# ORINDA WATER TREATMENT PLANT DISINFECTION IMPROVEMENTS PROJECT

Final Supplemental Environmental Impact Report  
SCH #2019080297

Prepared for  
East Bay Municipal Utility District

November 2020

## Existing Conditions Peak Hour Intersection Traffic Volumes, Lane Configurations and Traffic Controls

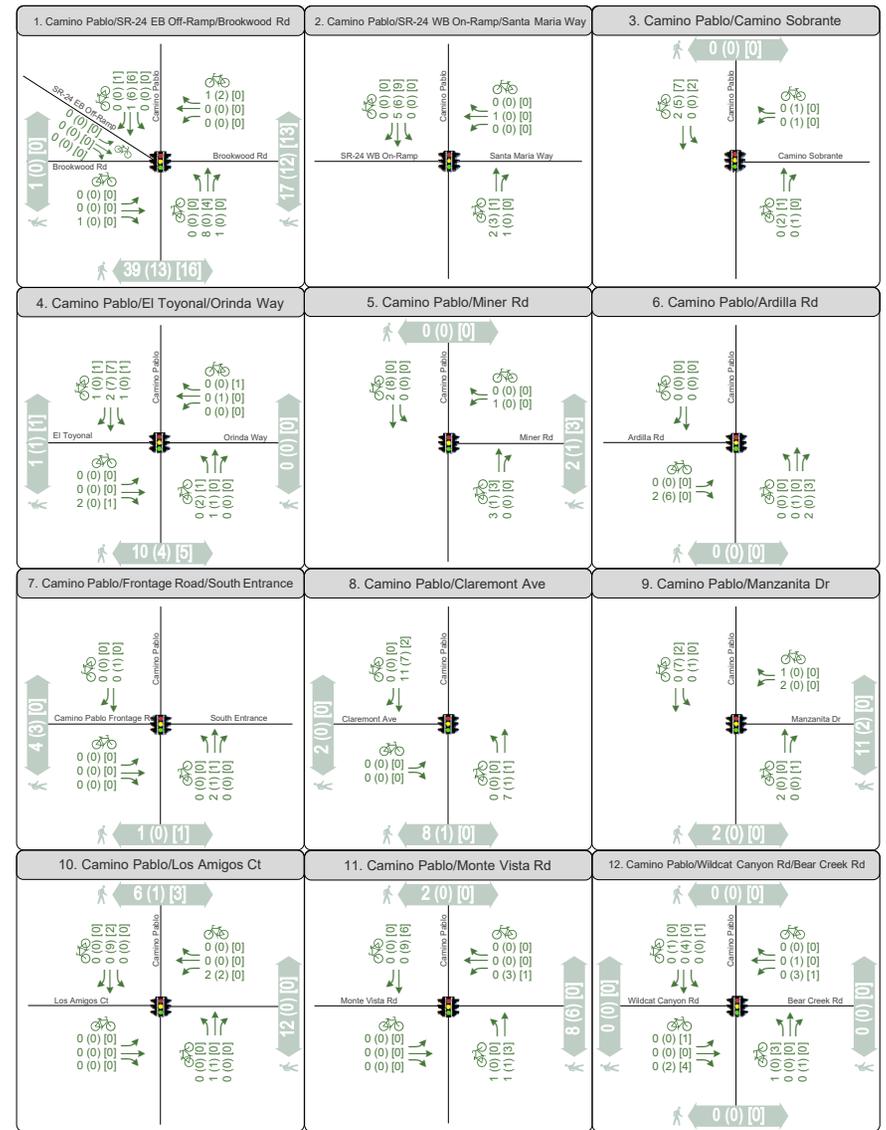
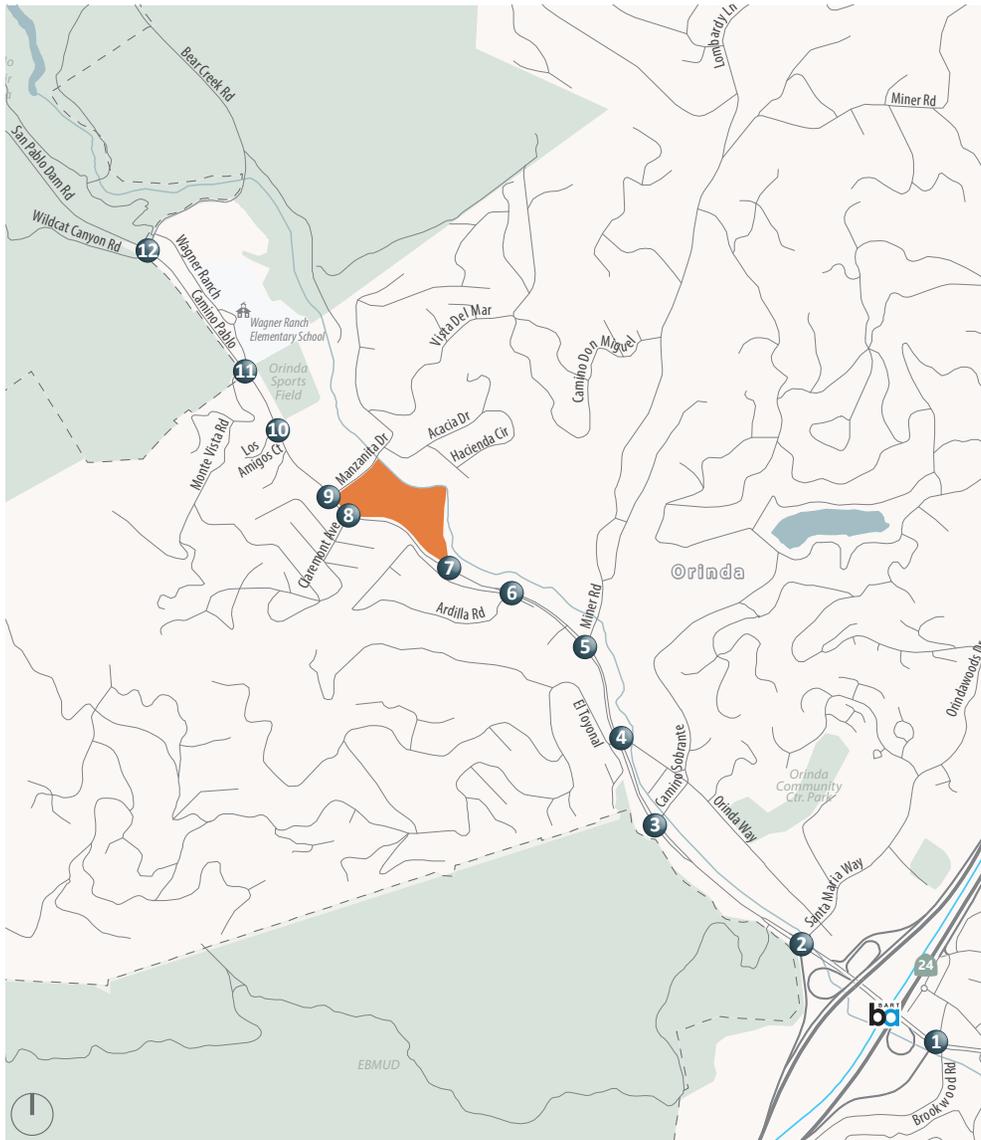
Comment: Several of the traffic volume figures (e.g., Figures 3, 7, and 9) in the Traffic and Circulation Technical Report Orinda Water Treatment Plant Disinfection Improvements Project (Fehr

Figures 3, 4, 7, and 9 of the Traffic and Circulation Technical Report (Draft Supplemental EIR Appendix G) contained a printing error that made those figures difficult to read. The printing error was corrected and the figures were posted to the Project's website at <https://www.ebmud.com/orwtpimprovements> on September 3, 2020. The corrected figures are also included in this chapter.
